Change Order No. #1

Project: 800 West Water Line Project
Owner: Pleasant View City
Contractor: Allied Underground Technology

Description of Change(s): extend water line replacement into north cul-de-sac of 800 West; add air/vac station at connection to existing water line; replace bid item 11 with item 109

800 WEST WATER LINE PROJECT

2" AIR/VACUUM RELIEF STATION

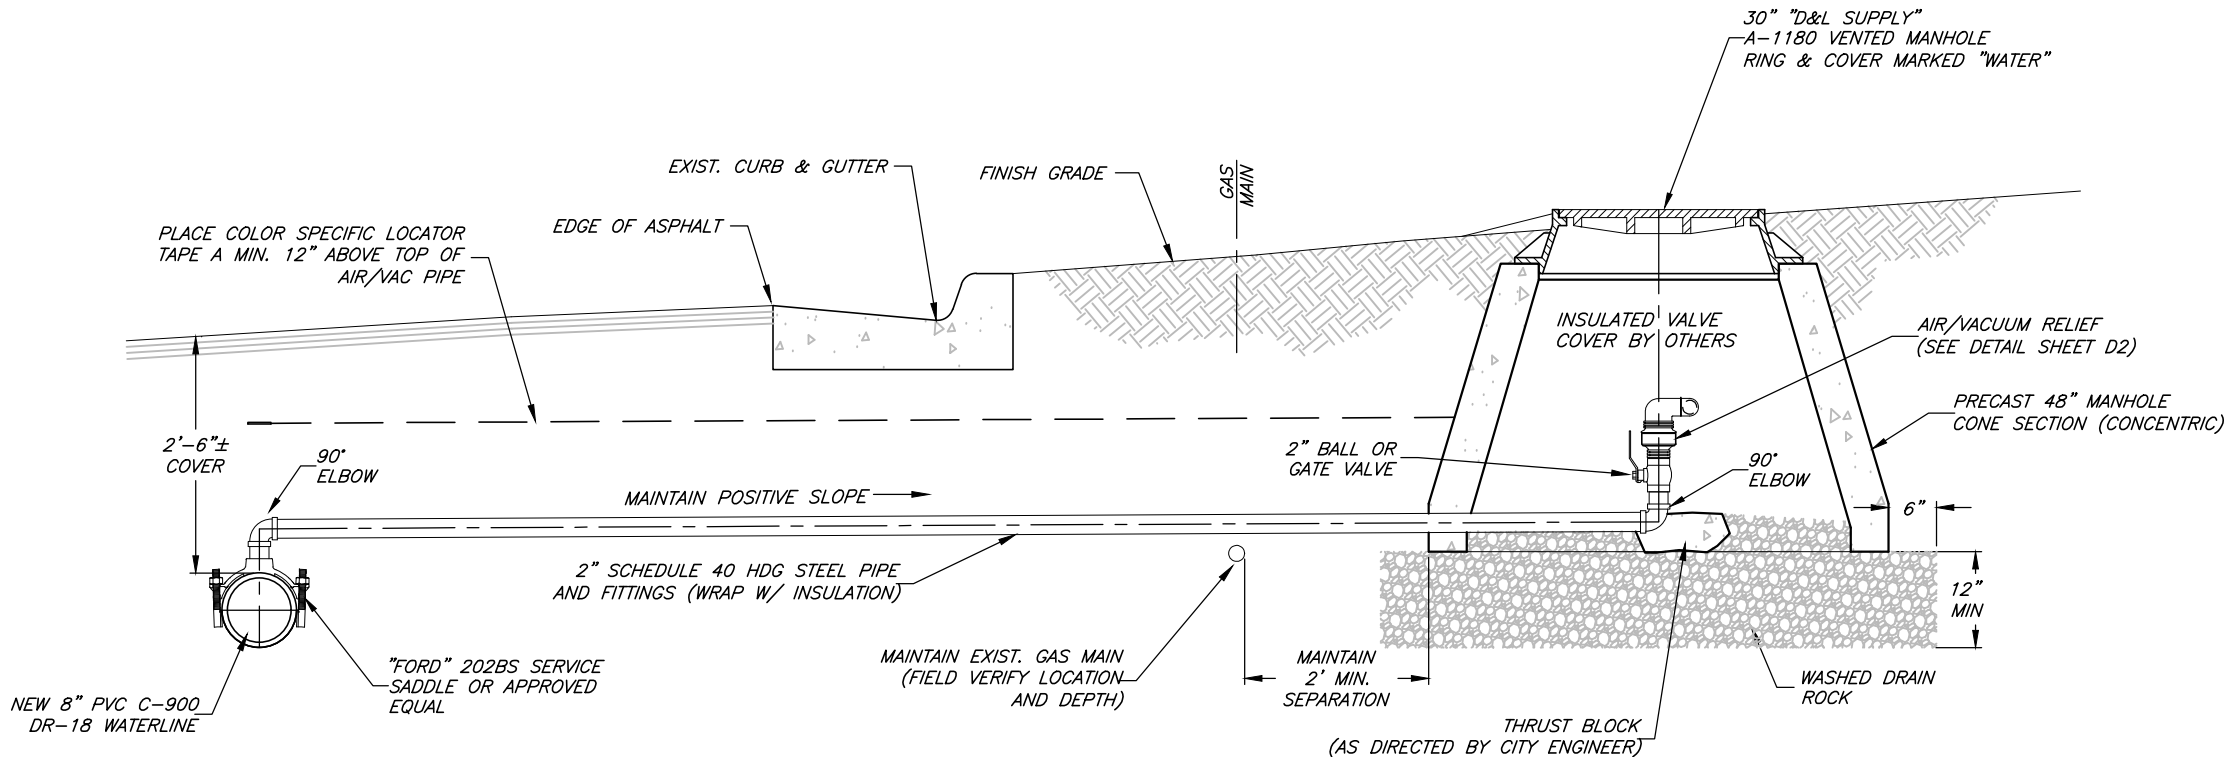
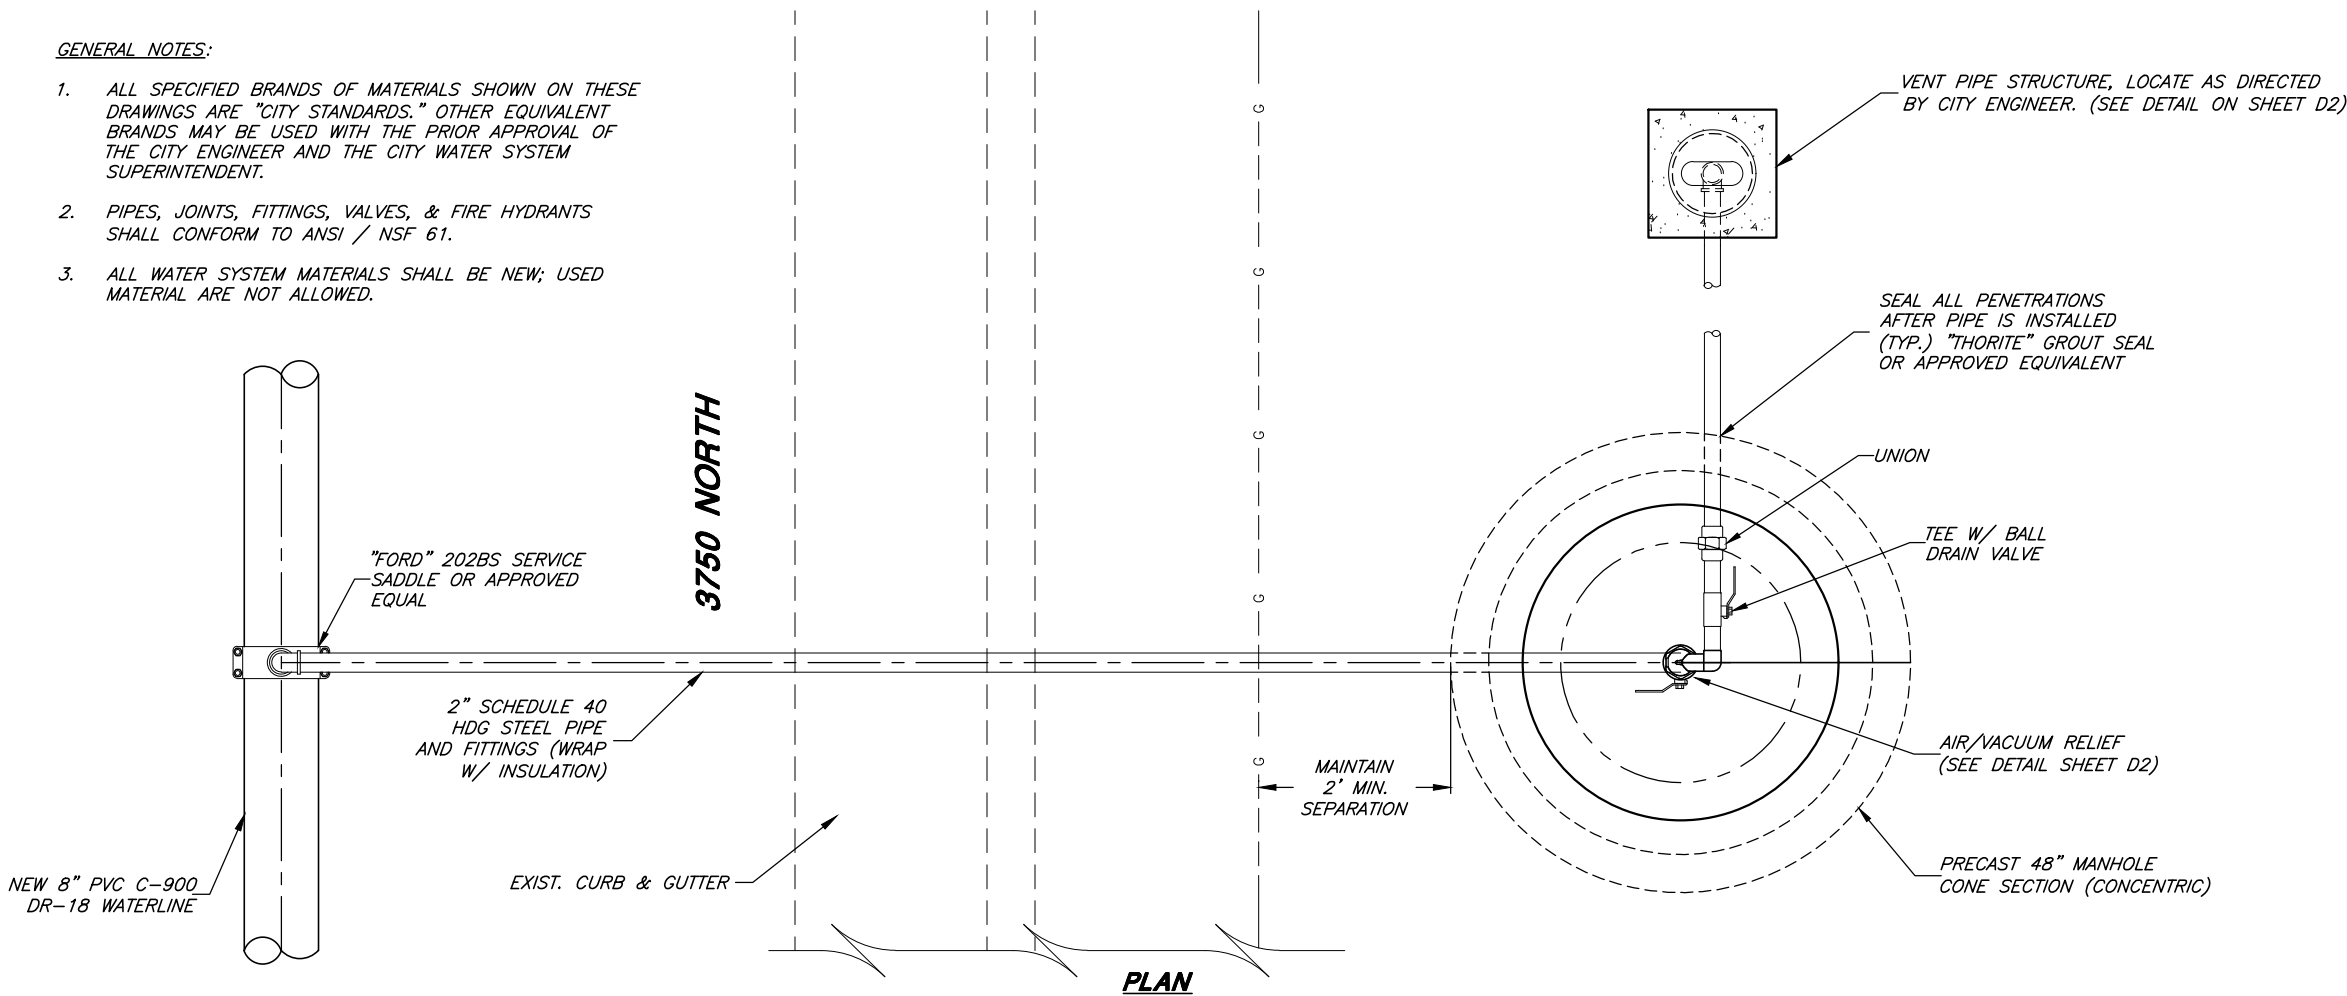
AUT is providing this proposal for the labor and material to install a shallow air vac. The price is needed since the existing pipe at the tie in location is very shallow. The price includes the cost to excavate the area around the new pipe, install the saddle and 2" piping with insulation, bedding material, excavation to area behind the curb, excavate area for manhole, install manhole on rock with piping and fittings and thrust block, excavate area to the side for vent pipe and vent structure, form and pour concrete vent base, install vent cover, backfill and compact, restore landscaping and clean up. Price also includes our additional cost for travel and bonding.
